ADDENDUM # 02

Project: Mt Diablo Unified School District
Rio Vista Elementary, Mt Diablo Elementary & Meadow Homes Elementary
Acoustic Ceiling Tiles and Shade Coverings
19six #: 23118, 23119, & 23120

Bid #: 1962
Date: August 27, 2025

BUILDING 5 REFLECTED CEILING PLAN

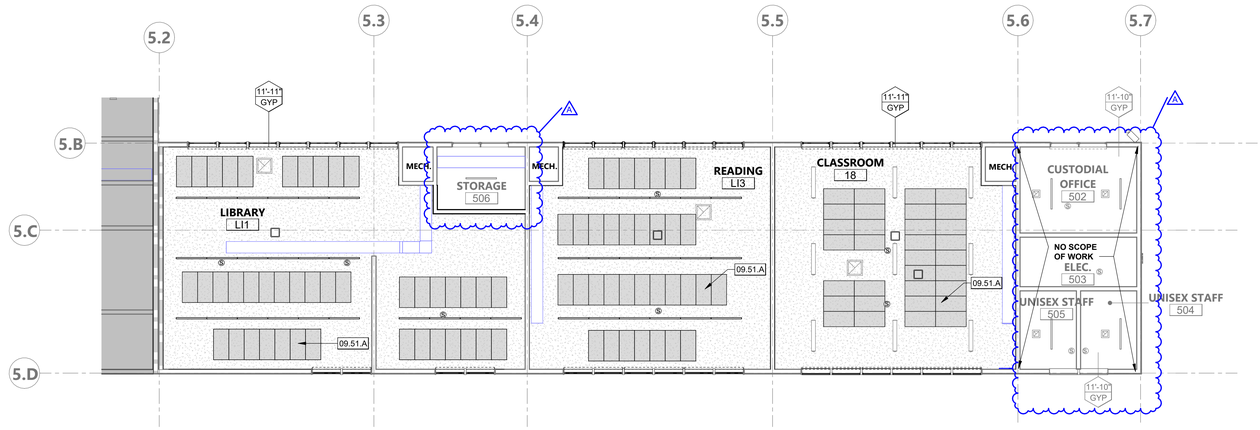
Item #6: **A-206 BLDG 5 REFLECTED CEILING PLAN** Edited keynote 09.51.A, changed/clarified the ceiling general notes, edited the LEGEND – CEILING to clarify existing ceiling items, and clarified areas of no scope.

FLOOR PLAN - BUILDING A RS | 1/8" = 1'-0" | 1

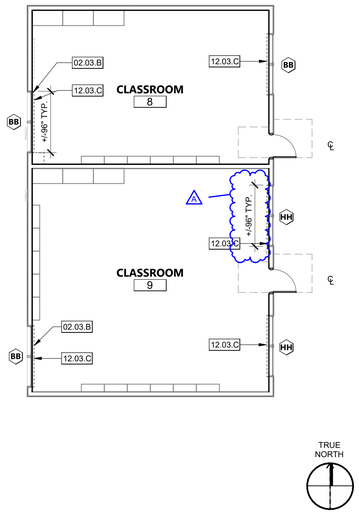
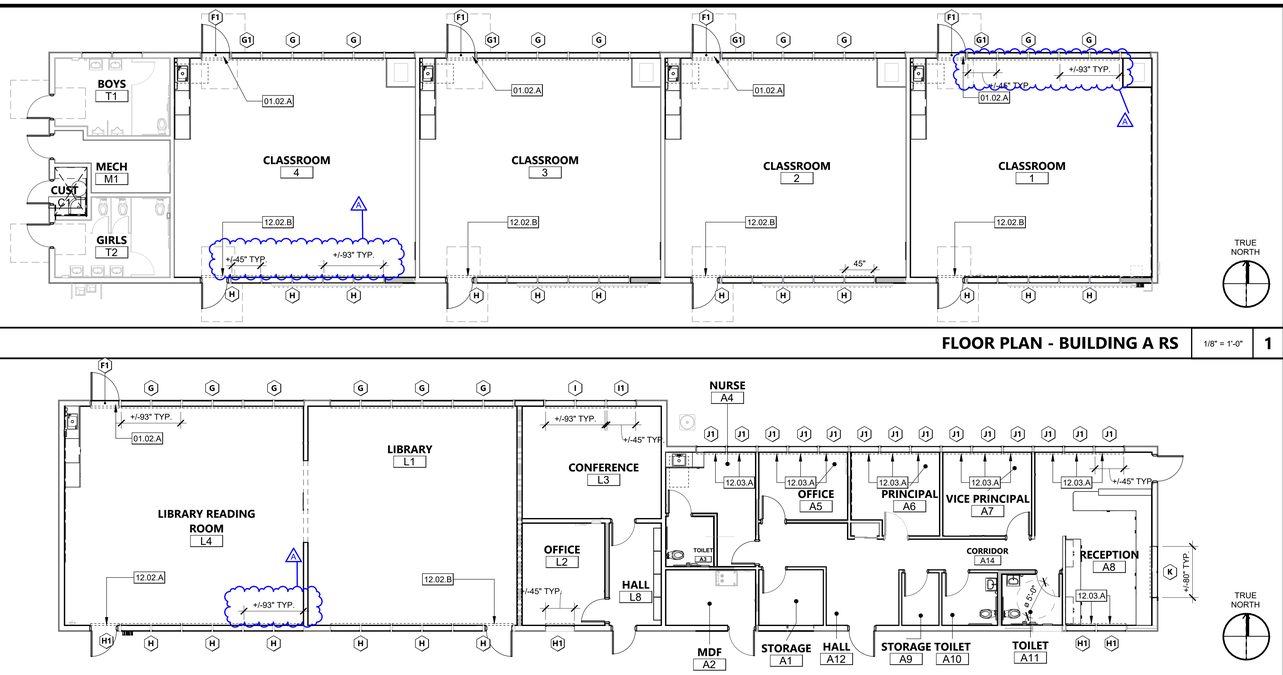
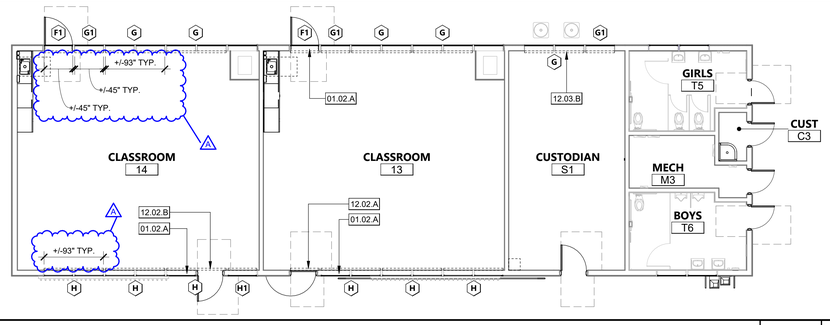
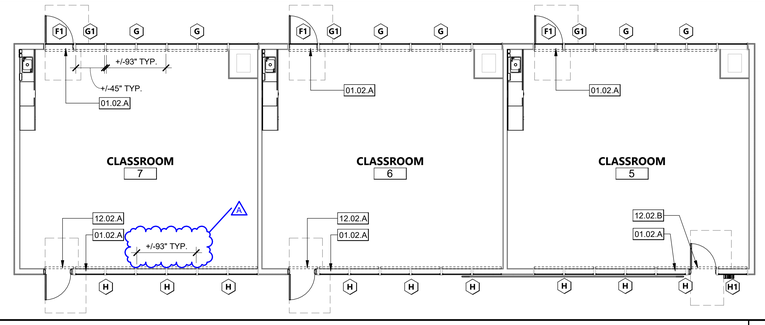
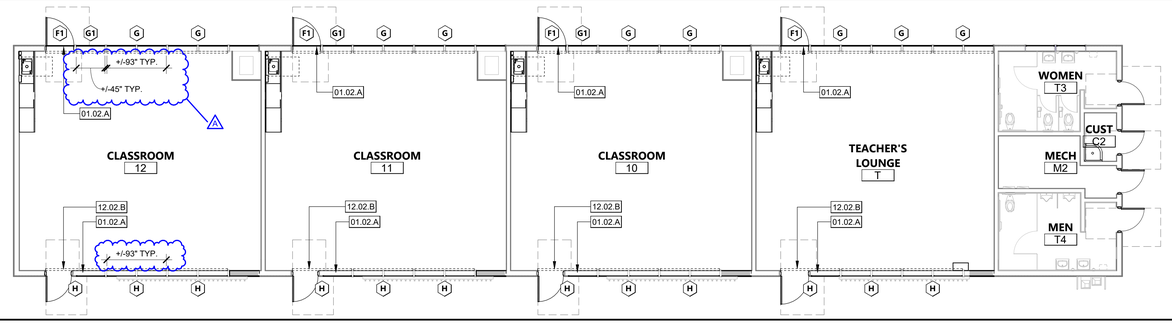
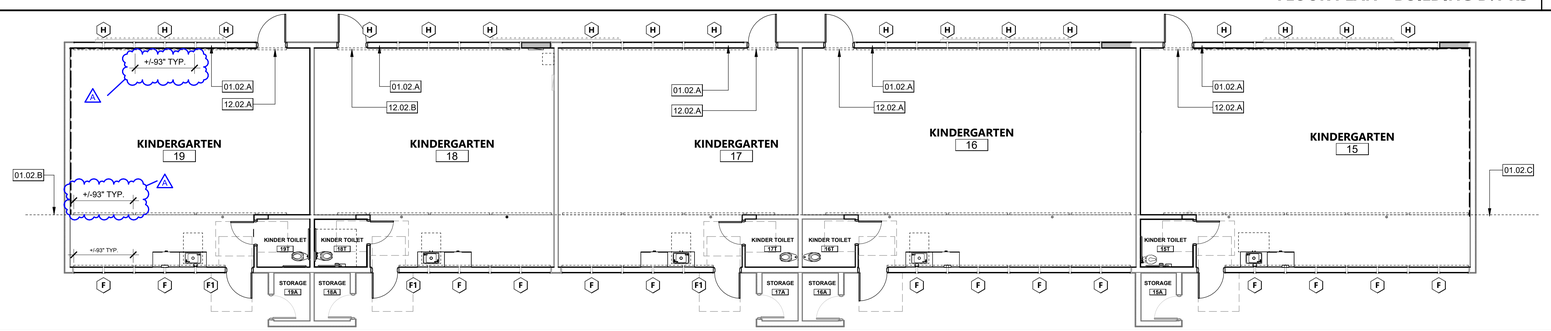
Item #4: **A-201 BLDG A. B. C. D. & E FLOOR PLANS** Edited detail call out on keynotes 01.02.B, 01.02.C, 12.03.A, 12.03.B to call out the corrected detail sheet. Added typical dimensions to windows.

BUILDING F FLOOR PLAN | 1/8" = 1'-0" | 2

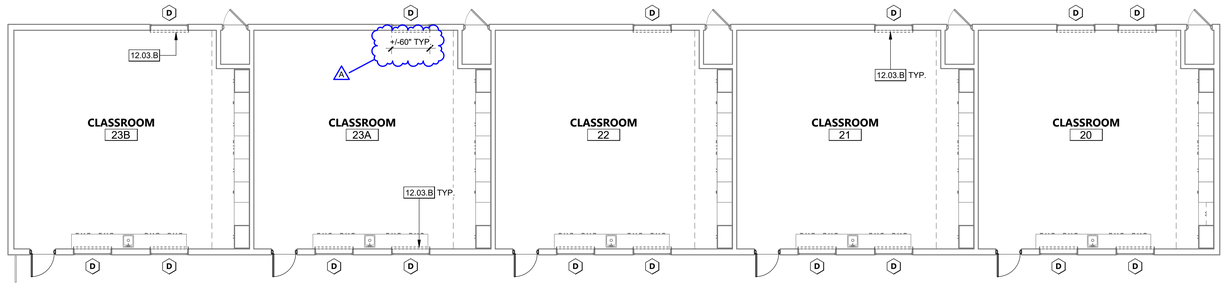
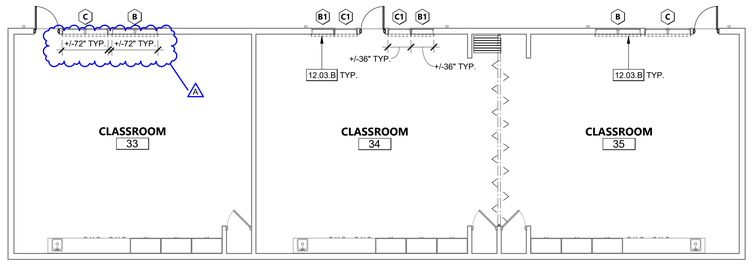
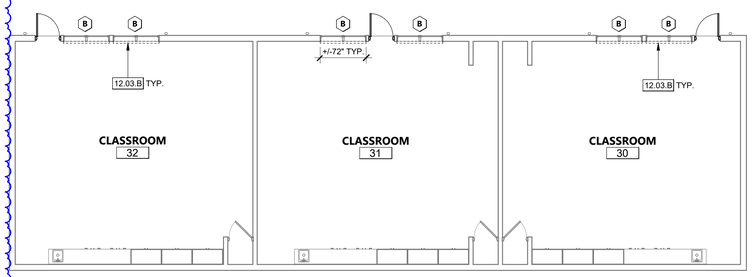
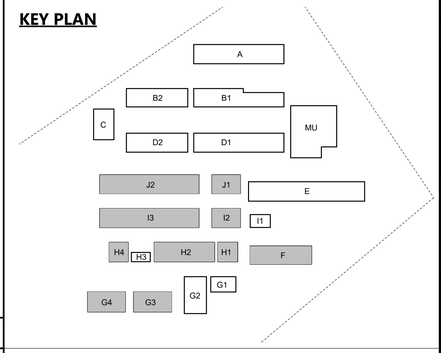
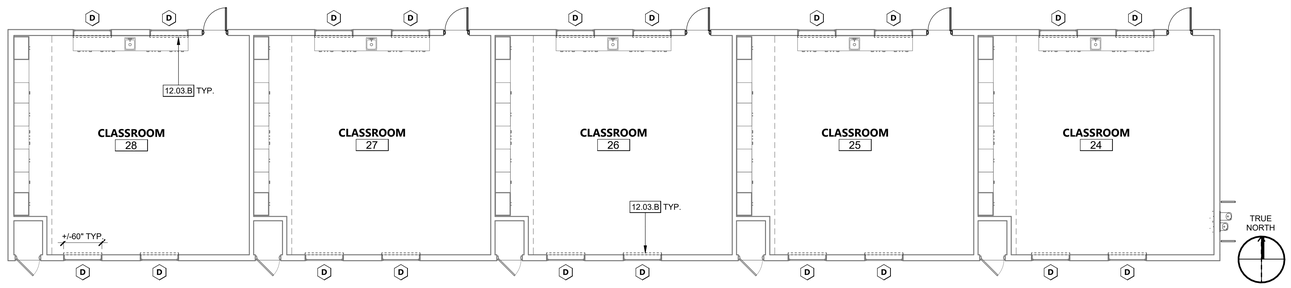
Item #5: **A-202 BLDG F, G, H, I & J FLOOR PLAN RS** Added typical dimensions to windows.

CEILING PLAN - BUILDING A | 1/8" = 1'-0" | 1

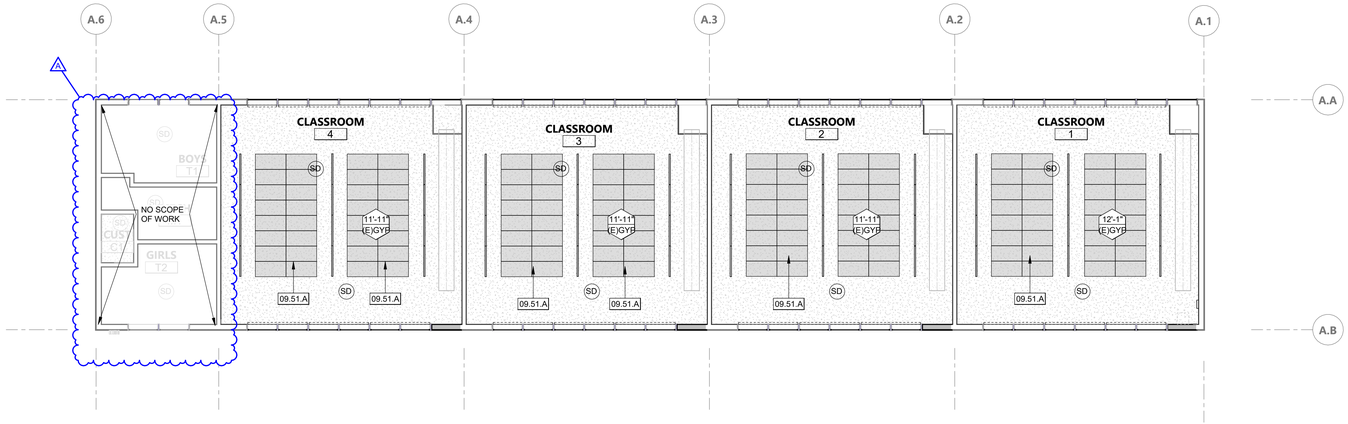
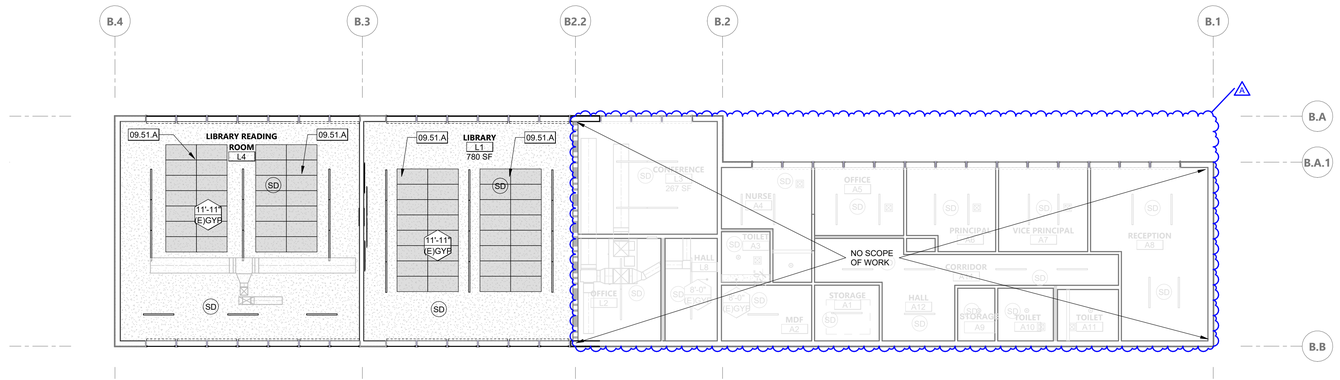
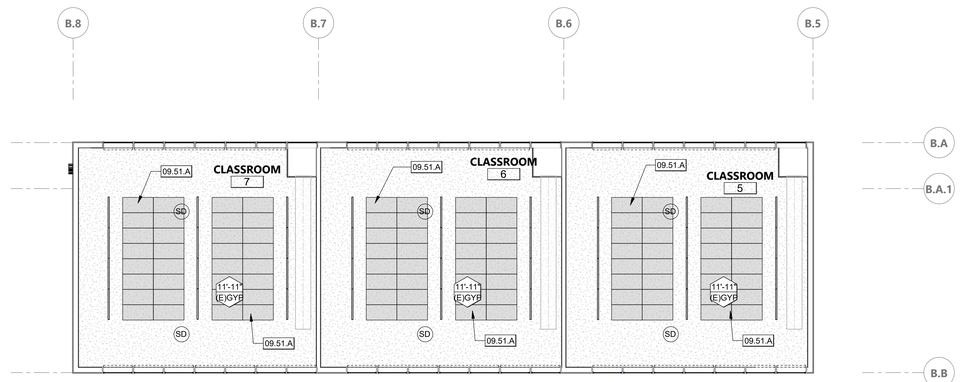
Item #6: **A-203 BLDG A & B REFLECTED CEILING PLAN** Edited keynote 09.51.A, changed/clarified the ceiling general notes, edited the LEGEND – CEILING to clarify existing ceiling items, clarified areas of no scope, and removed a view

CEILING PLAN - BUILDING D.1 | 1/8" = 1'-0" | 1

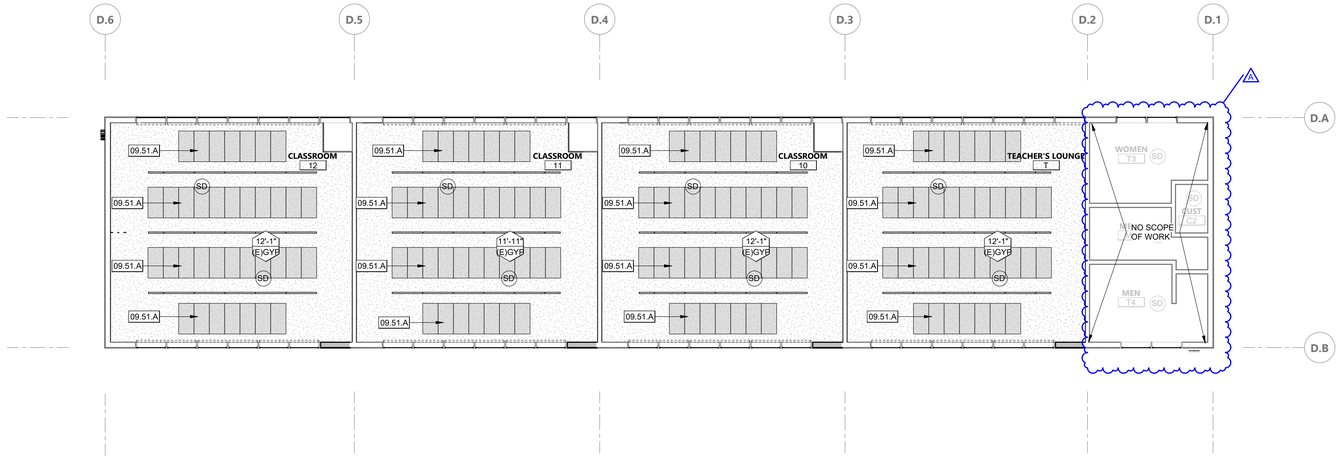
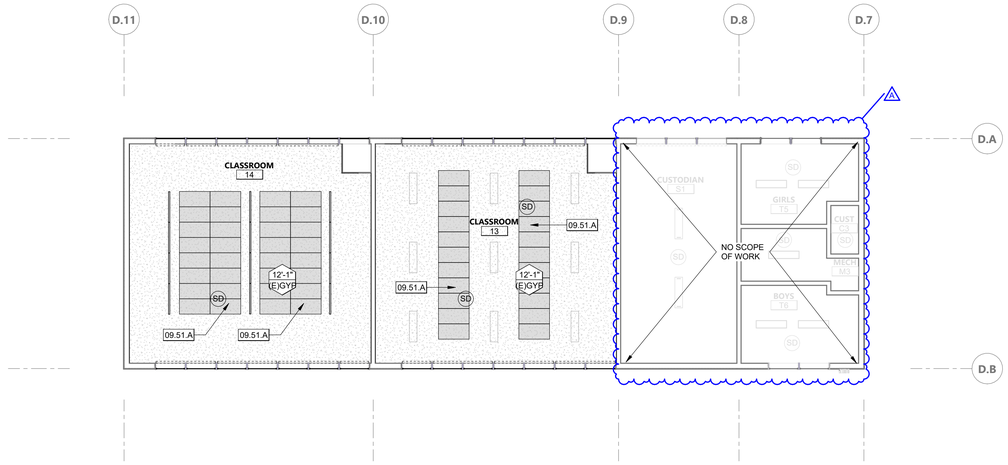
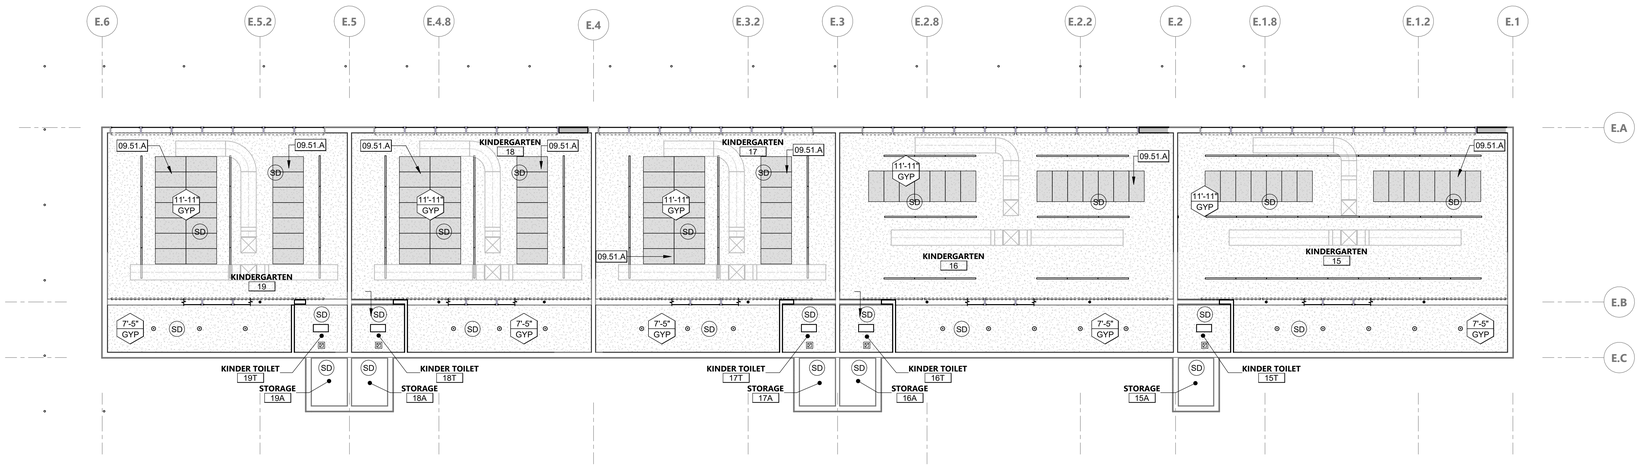
Item #7: **A-204 BLDG D & E REFLECTED CEILING PLAN** Edited keynote 09.51.A, changed/clarified the ceiling general notes, edited the LEGEND – CEILING to clarify existing ceiling items, and clarified areas of no scope.
